**PLEASANT PRAIRIE PLAN COMMISSION MEETING
VILLAGE HALL AUDITORIUM
9915 39th AVENUE
PLEASANT PRAIRIE, WISCONSIN
6:00 P.M.
March 26, 2018**

**PLEASANT PRAIRIE PLAN COMMISSION MEETING
VILLAGE HALL AUDITORIUM
9915 39TH AVENUE
PLEASANT PRAIRIE, WISCONSIN
6:00 P.M.
February 26, 2018**

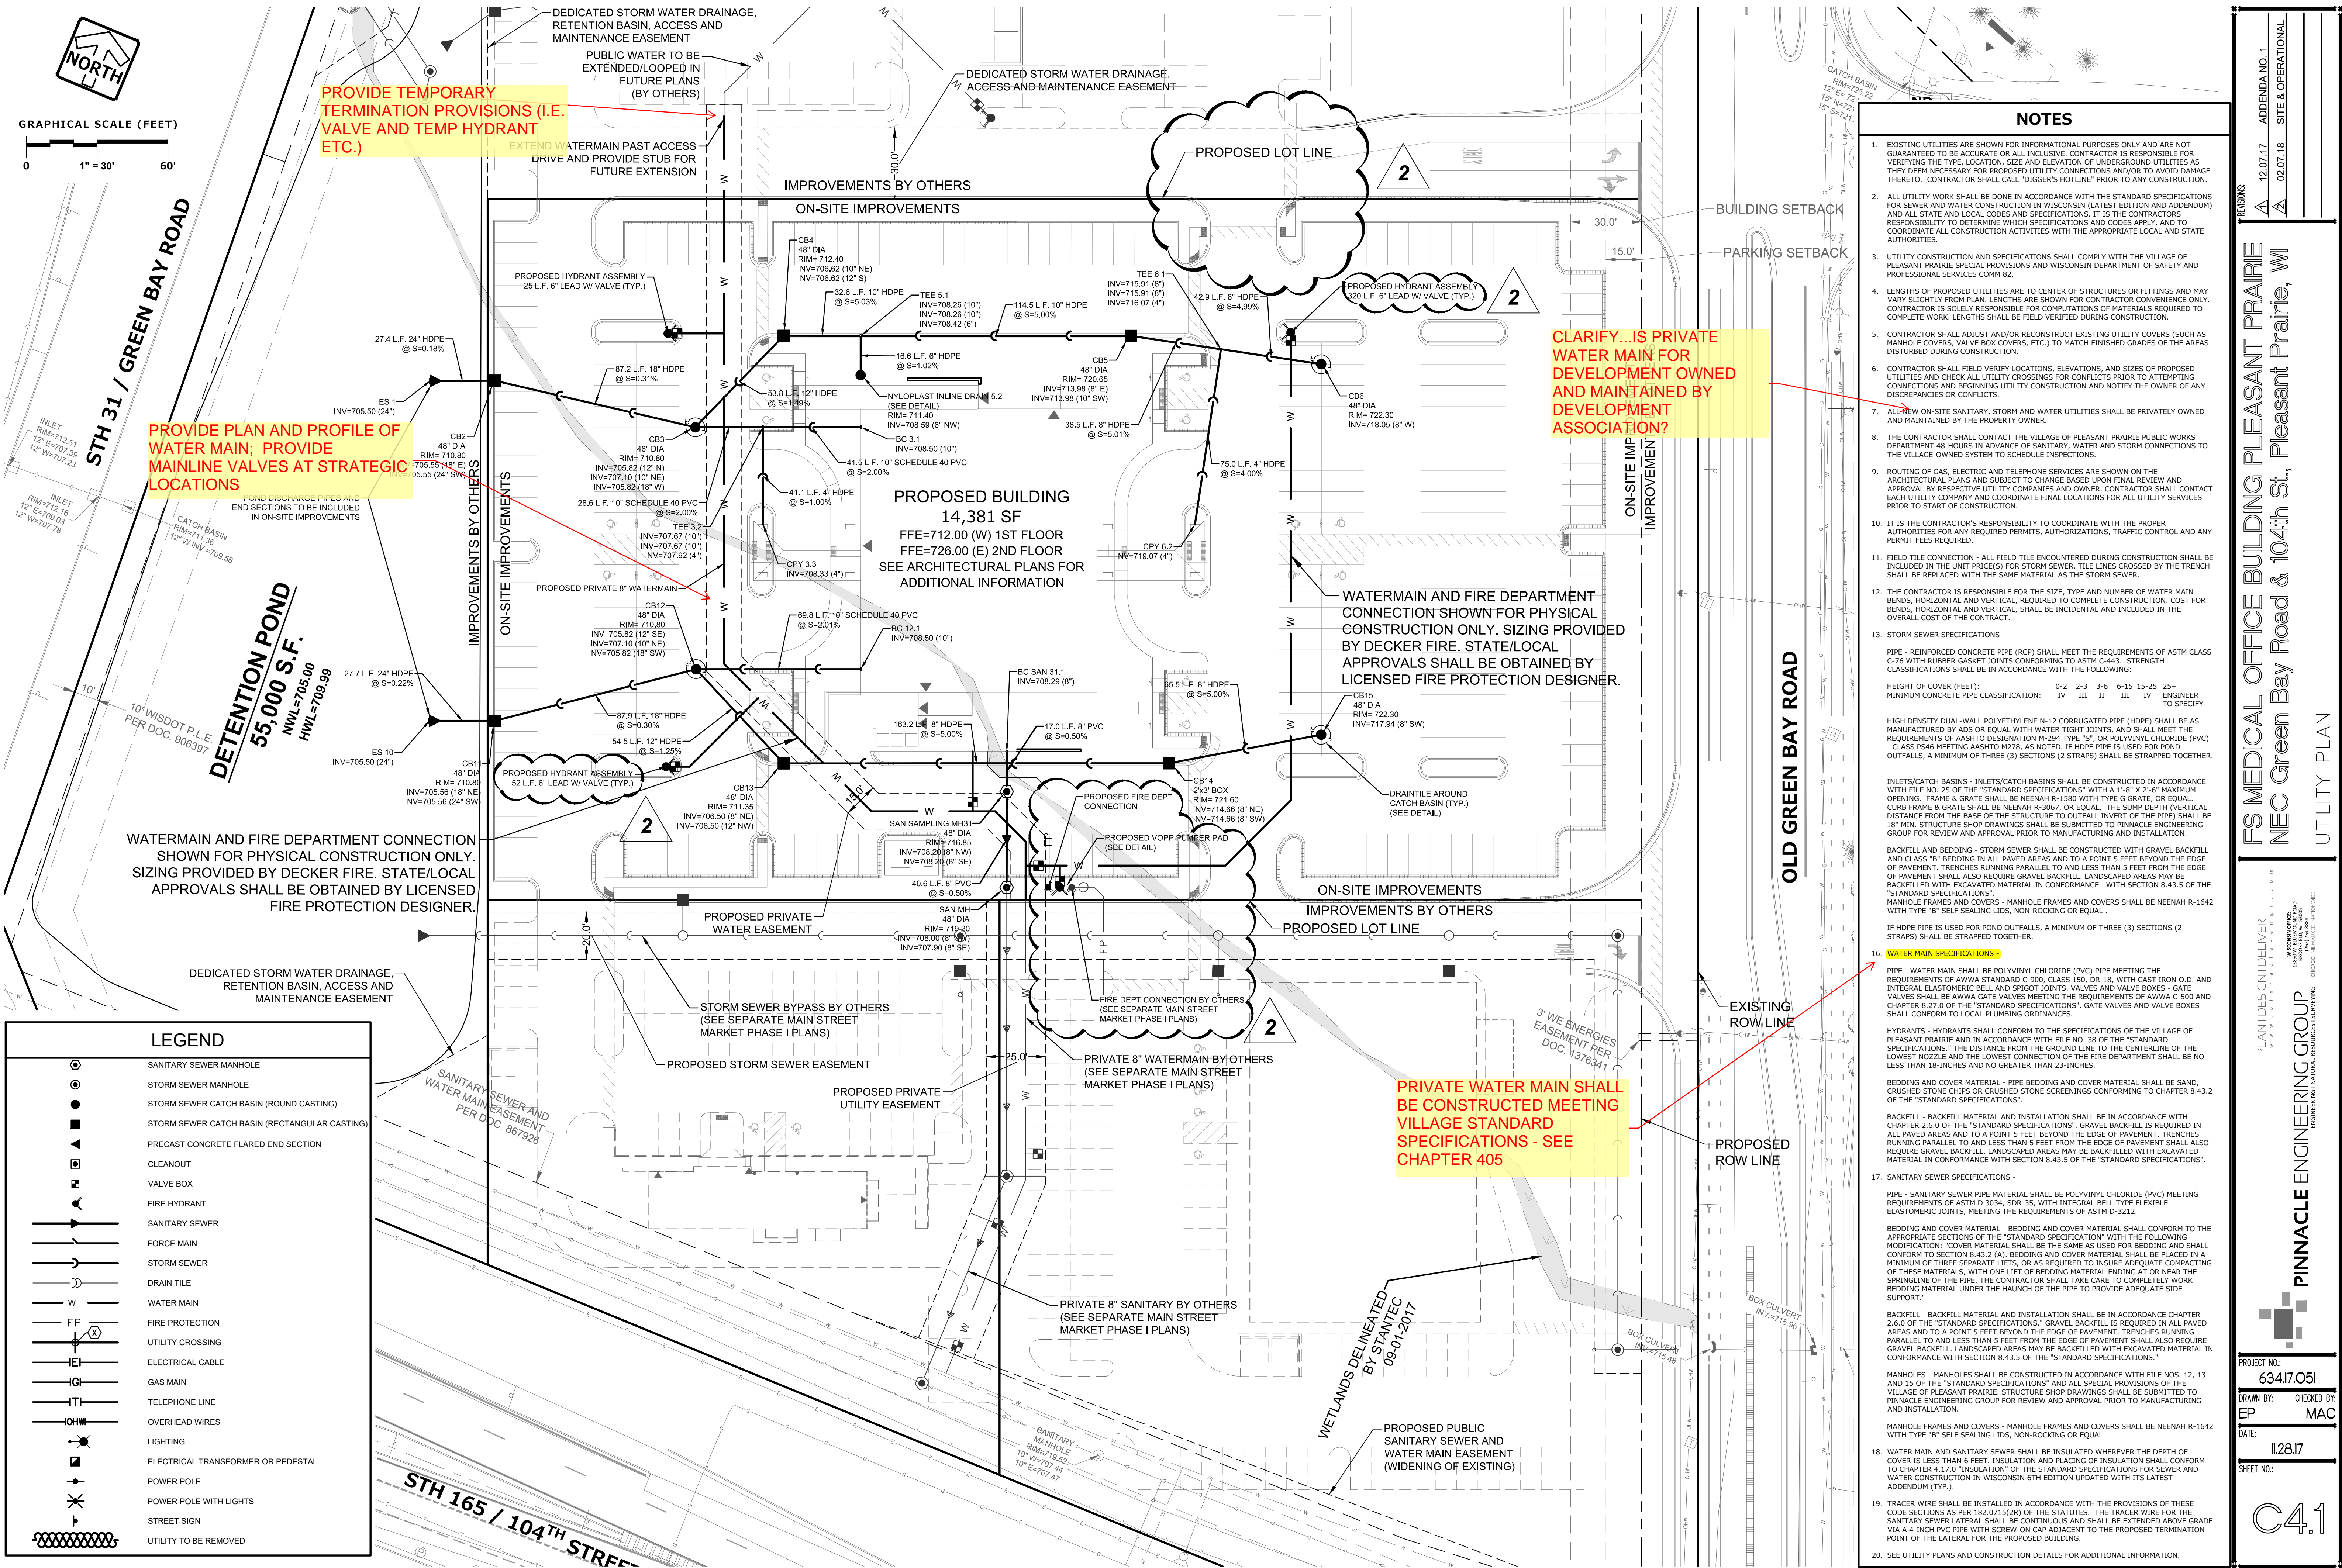
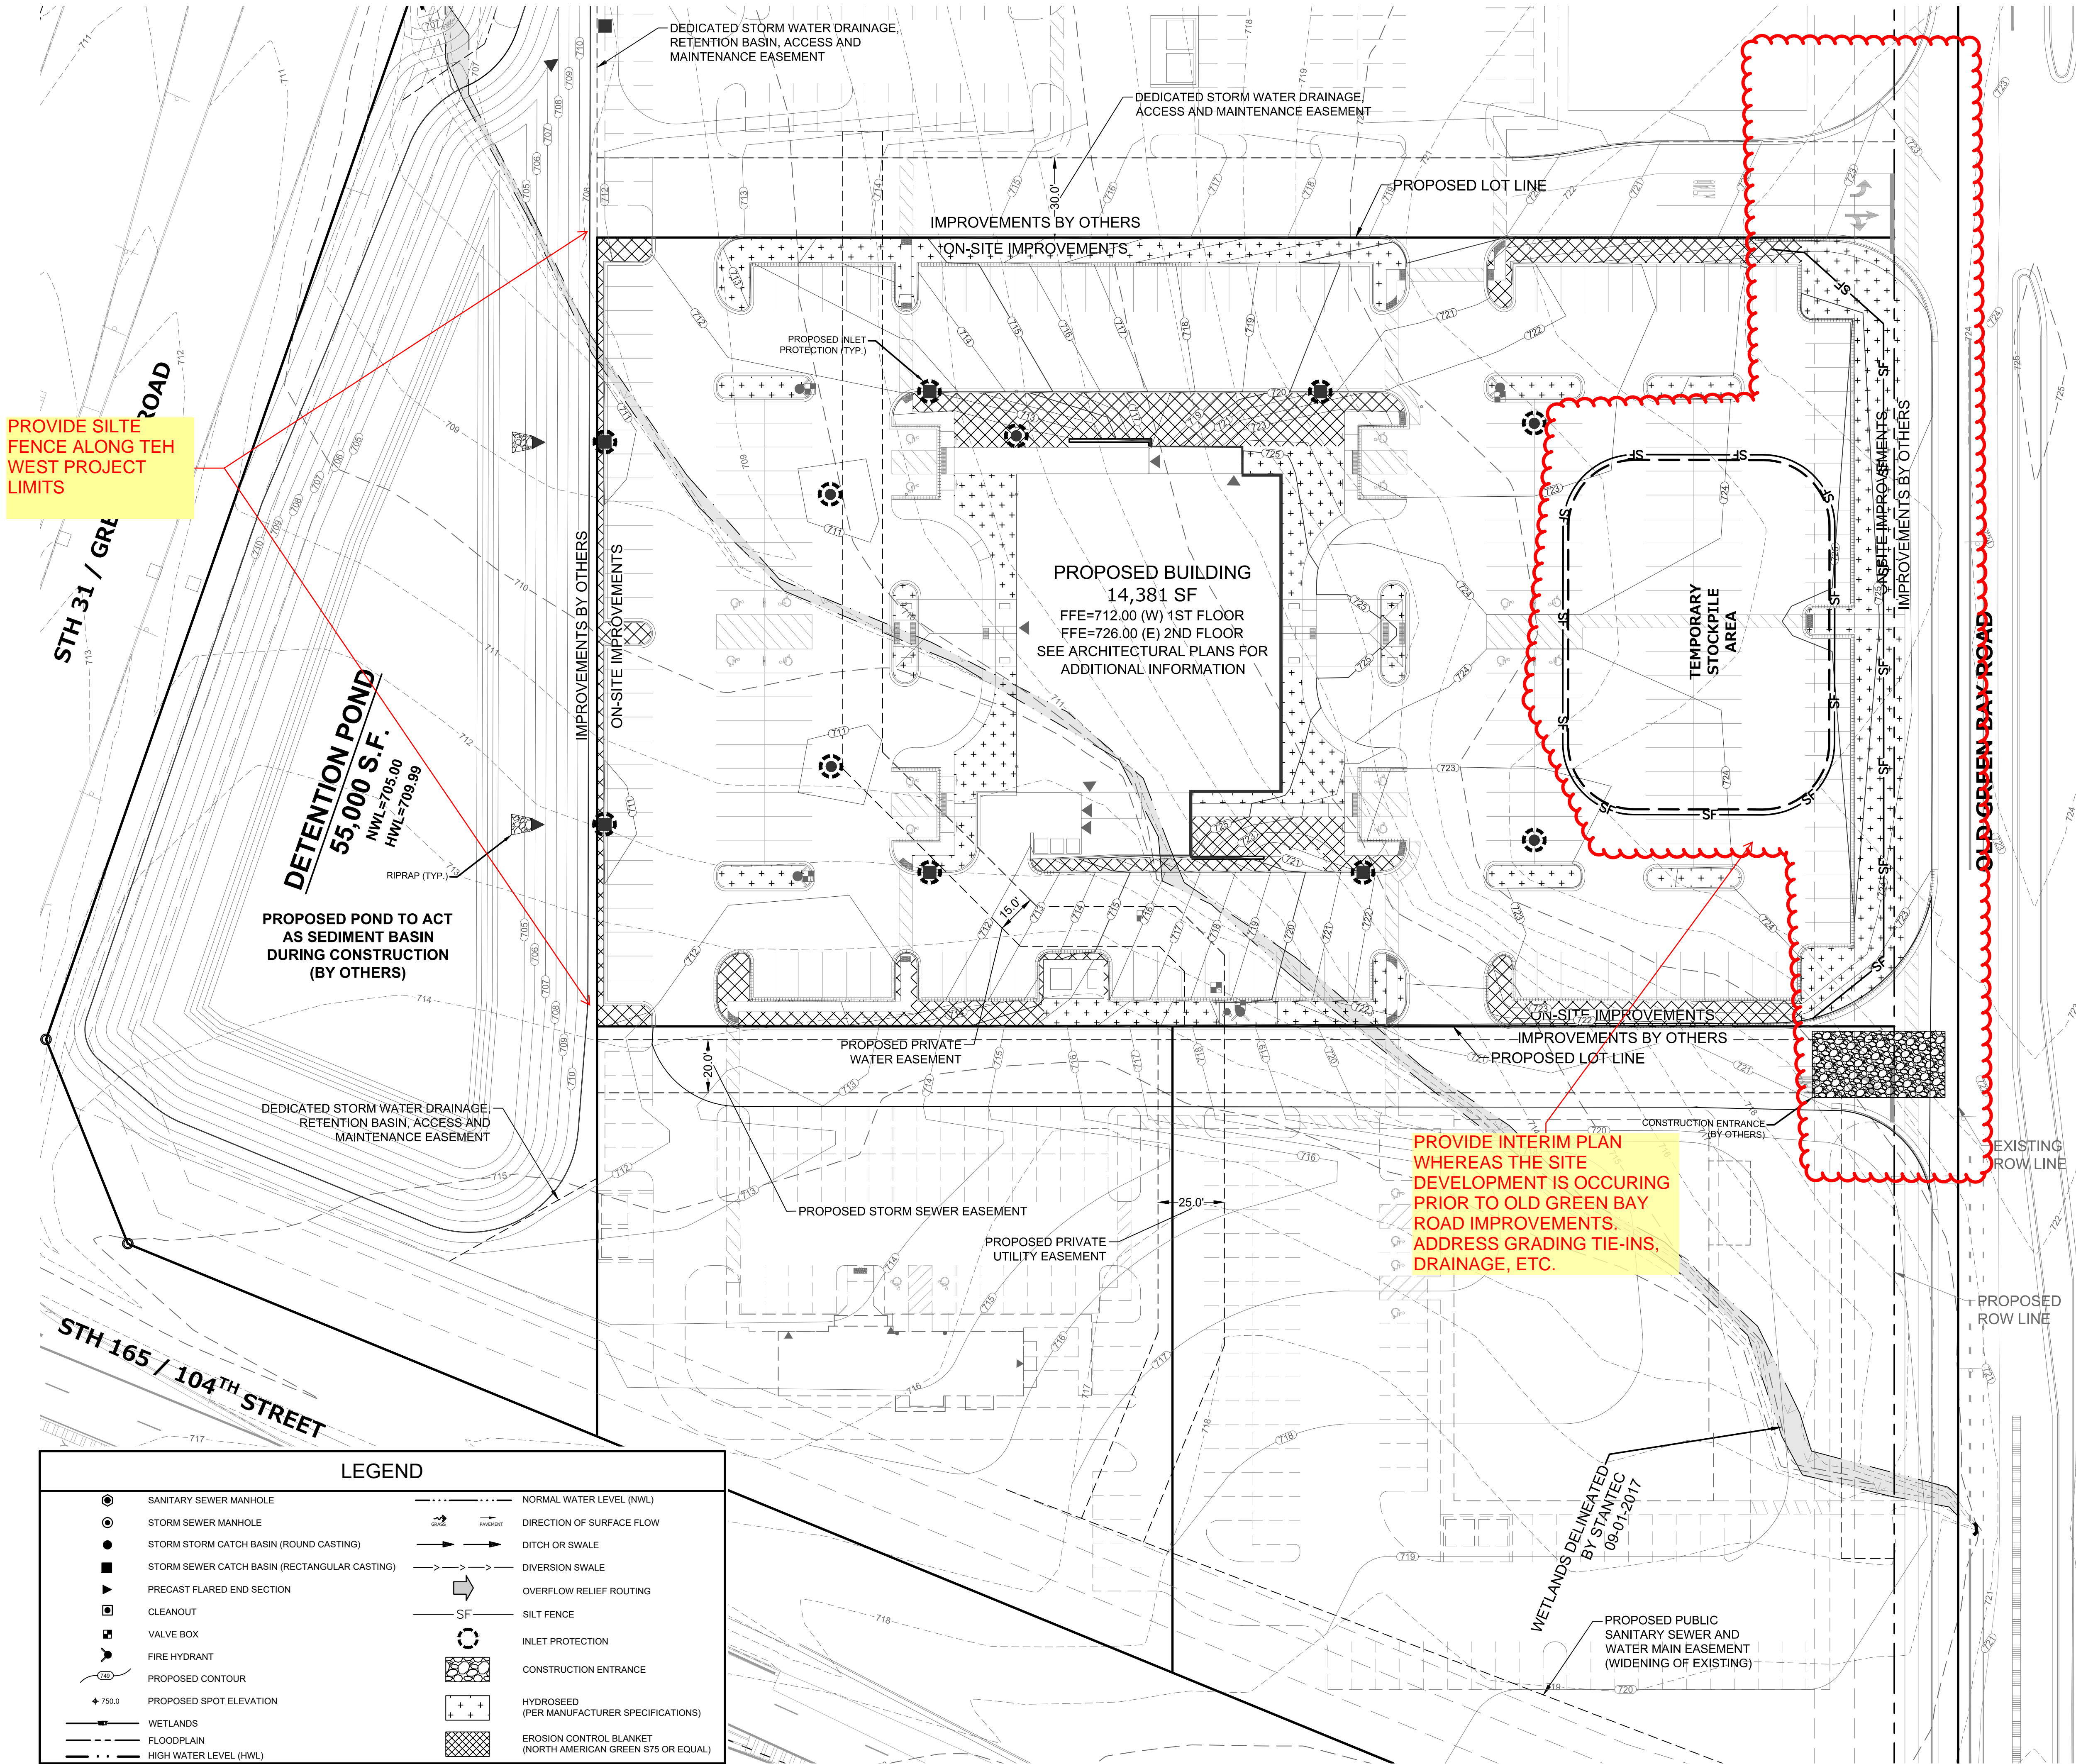
1. FDC location and truck turn-out; sheet C300 depicts FDC location with hydrant spaced too far out. Refer to Village FDC specifications. Additional detail required. Hydrant may require to be relocated.
2. See modified/attached sheet C300 for hydrant additions to area.
3. Plans do not depict pump/riser room location. Need to identify.
4. Roadway widths are not dimensioned.
5. As further details for the project and buildings develop, the Fire Department will have additional comments.

SHEET C-1 of C-5

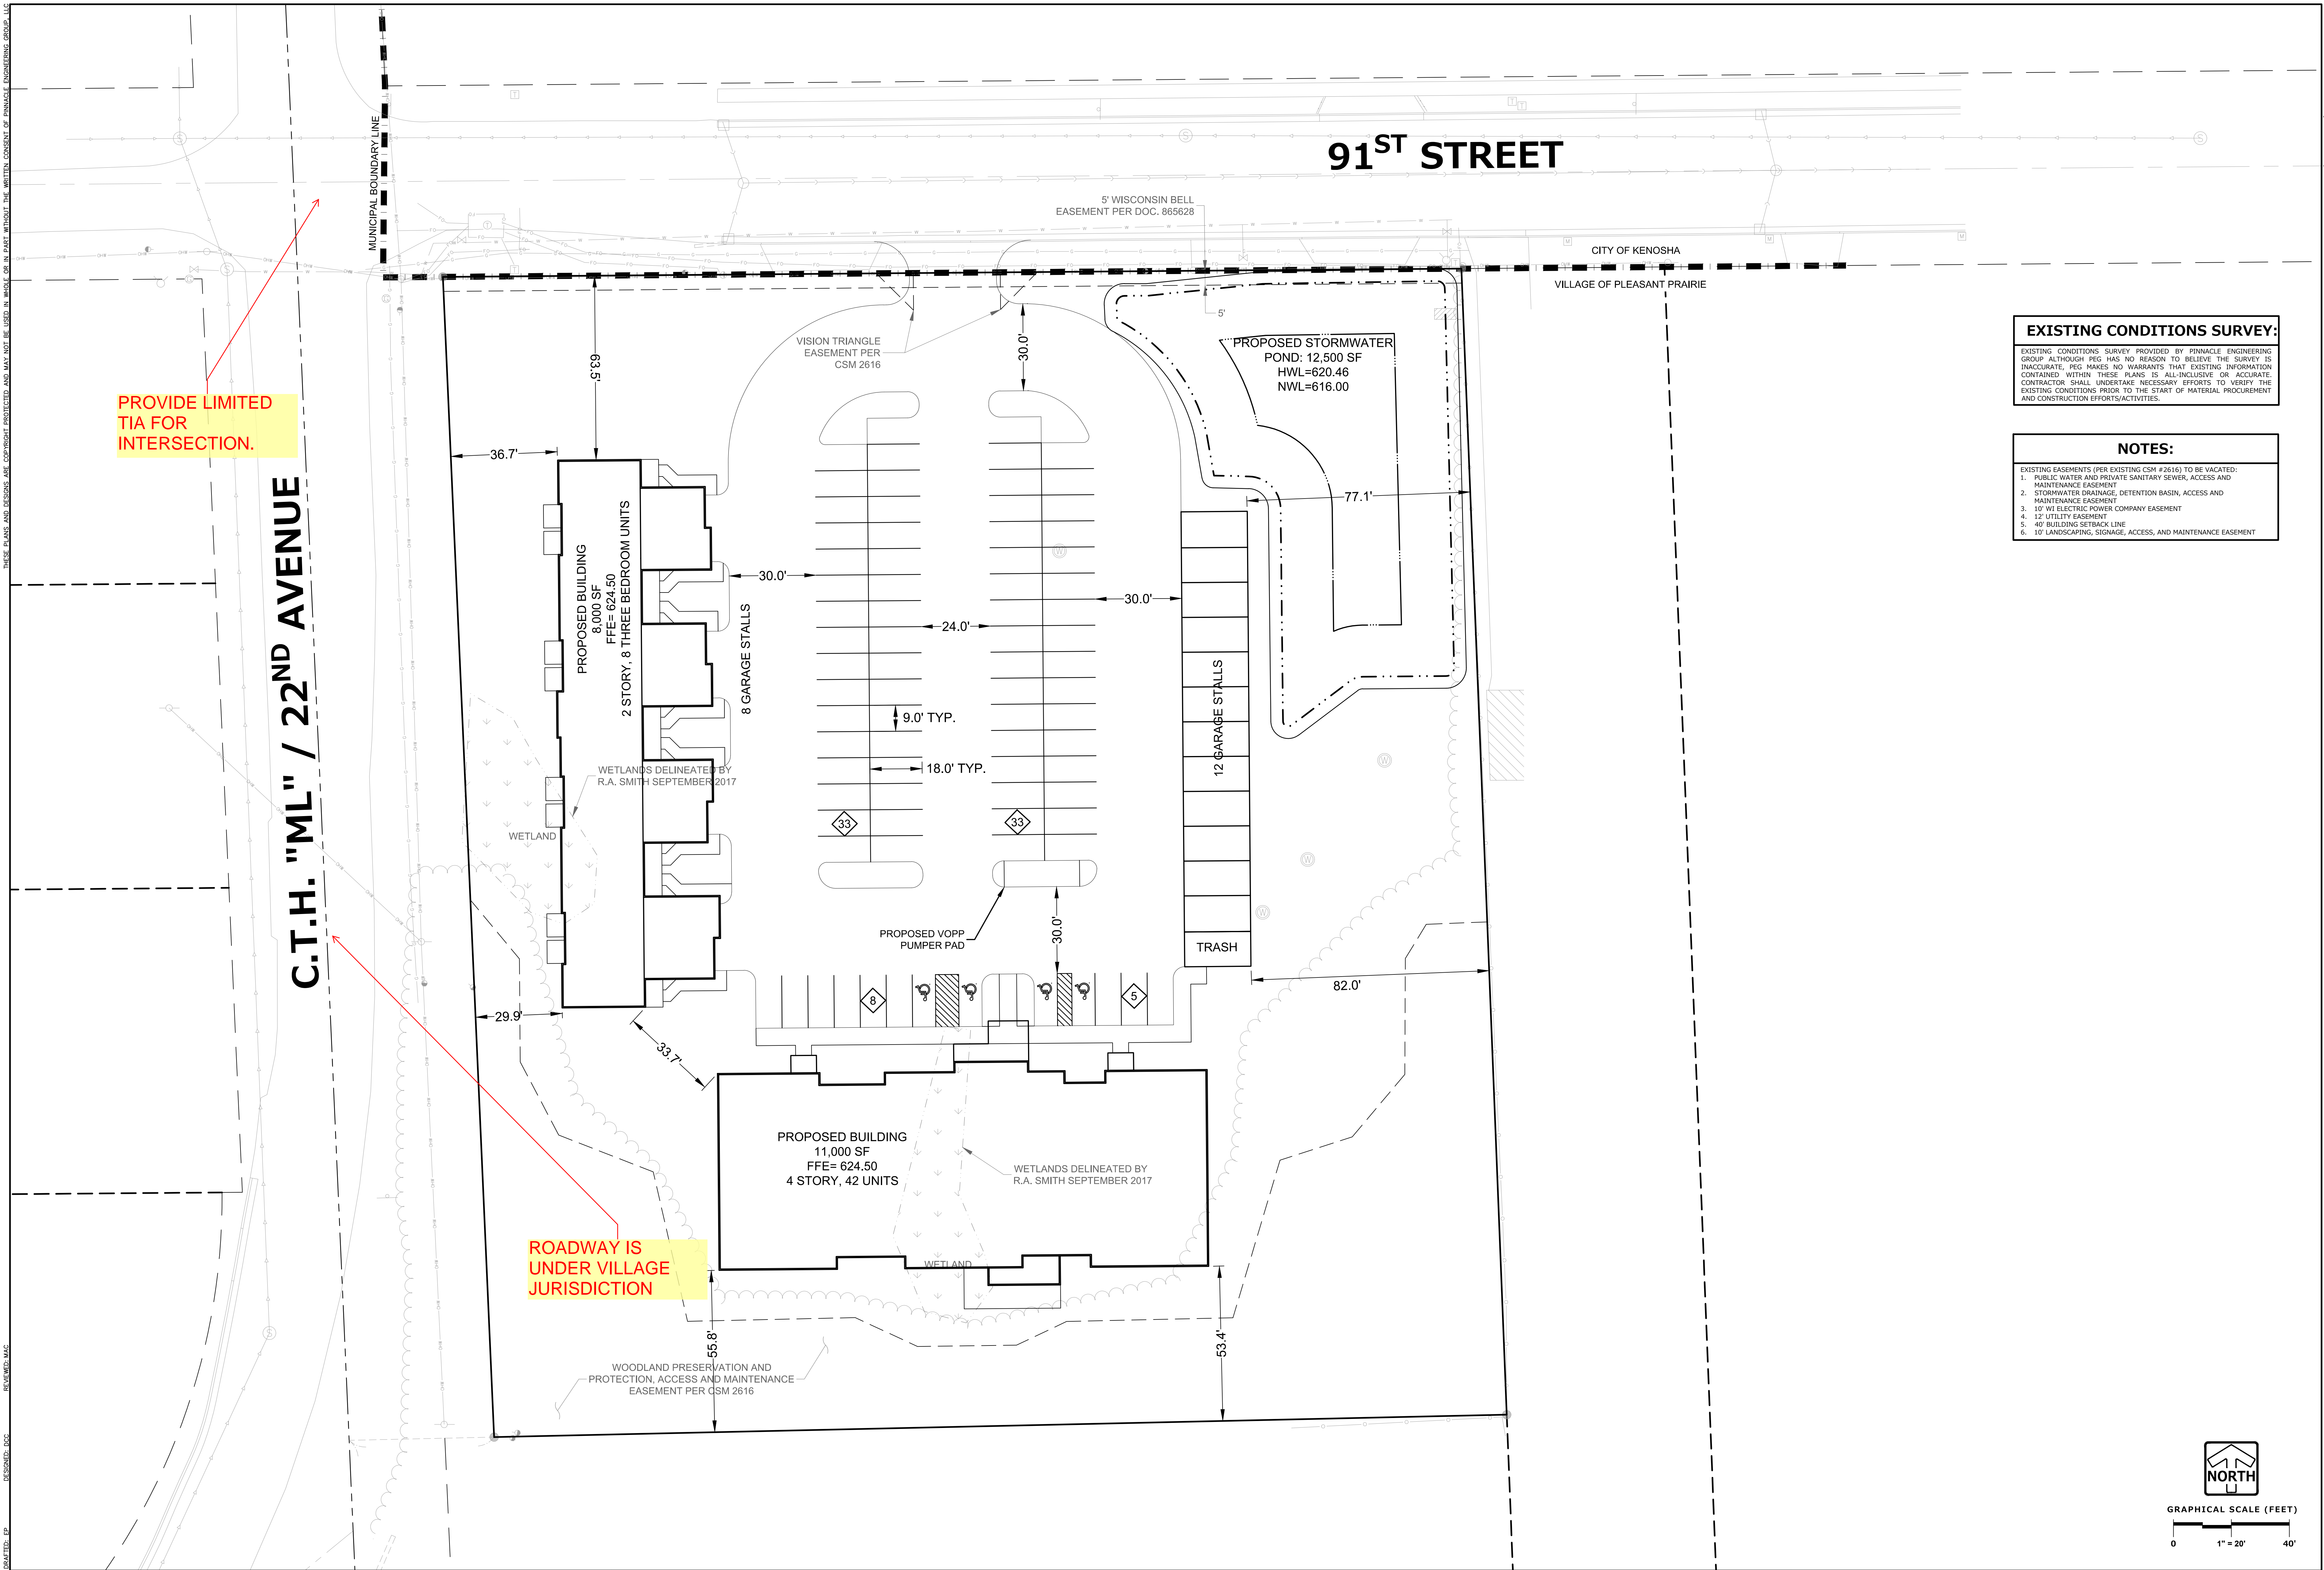
- a. 22nd Avenue is no longer CTH ML. Correct all plan sheets.
 - b. Sheet C-1 – Add all government agency, owner, engineer and architect contact information. Add all City DPW, Engineering and ROW contact information (91st Street ROW is in the City of Kenosha).

- c. Sheet C-1 – Clearly show City/Village corporate limit line on the location map.
 - d. Sheet C-3 – How long do the groundwater monitoring wells need to remain on the site?
